**4 LDA2021/0124
50-52 Buffalo Road, Gladesville**

Part demolition of existing buildings, construction of industrial building, installation of weighbridges, and use as a waste or resource waste transfer station for scrap metals.

City of Ryde Local Planning Panel Report

DA Number	LDA2021/0124
Site Address & Ward	50-52 Buffalo Road, Gladesville East Ward
Zoning	IN2 Light Industrial
Proposal	Part demolition of existing buildings, construction of industrial building, installation of weighbridges, and use as a waste or resource waste transfer station for scrap metals
Property Owner	Watou Holdings Pty Ltd and DPV Investments Pty Ltd
Applicant	Garbis Simonian
Report Author	Kerry Gordon – Consultant Town Planner
Lodgement Date	20 April 2021

Figure 10: Plan showing footprint of buildings and swept path of semi-trailer accessing the site.

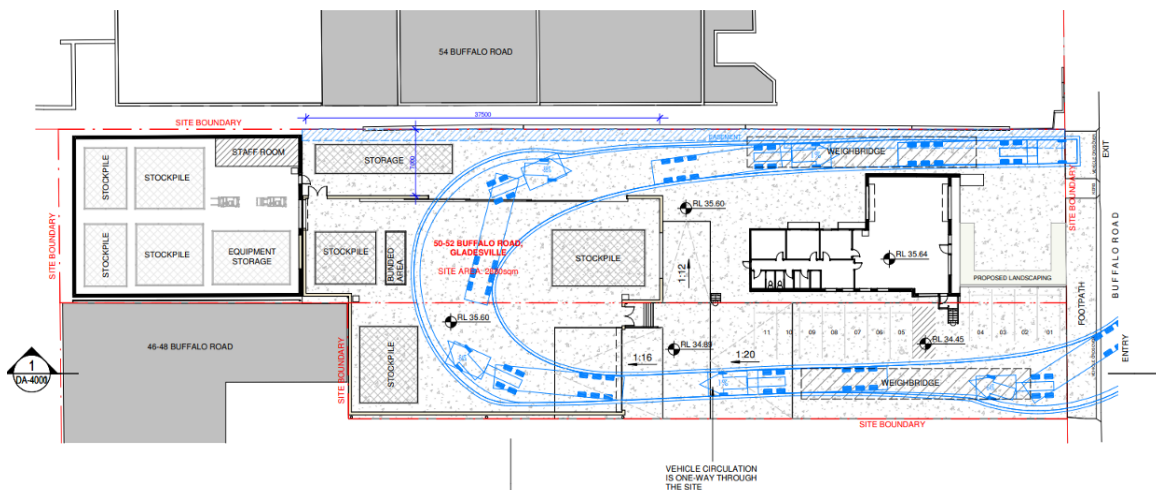
- *Looking at the swept path for the truck (page 10 of the PKA report), is there sufficient room for a truck to be unloaded while keeping shed doors closed? Further - the drawing on page 10 shows stockpiles located in a second building outside the main shed, and a forklift. Given this, it is necessary that the report address:*

Figure 11: Elevation plan showing proposed location for signage.

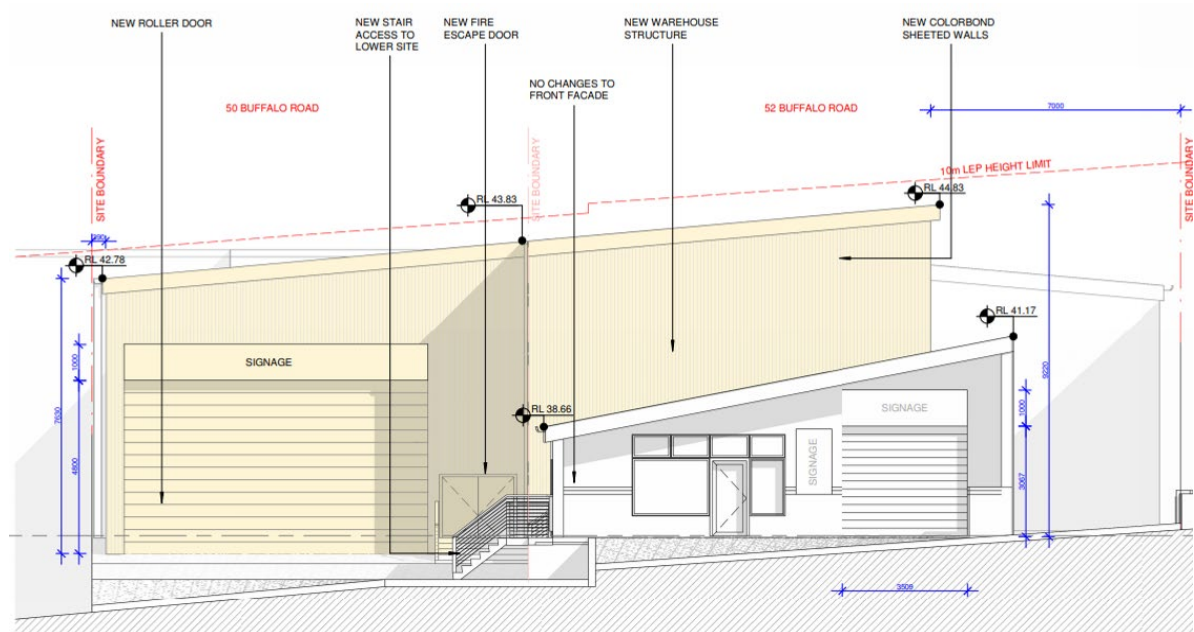
The application seeks approval for signage to be provided in three locations as can be seen on the elevation in Figure 11, however no information is provided in relation to

the signage. It is noted that the signage on the existing building which is identified as being retained at the front of the site is already located in the areas shown on the plan, however presumably a different signage content will be proposed. As no details of the signage are provided, it cannot be assessed.
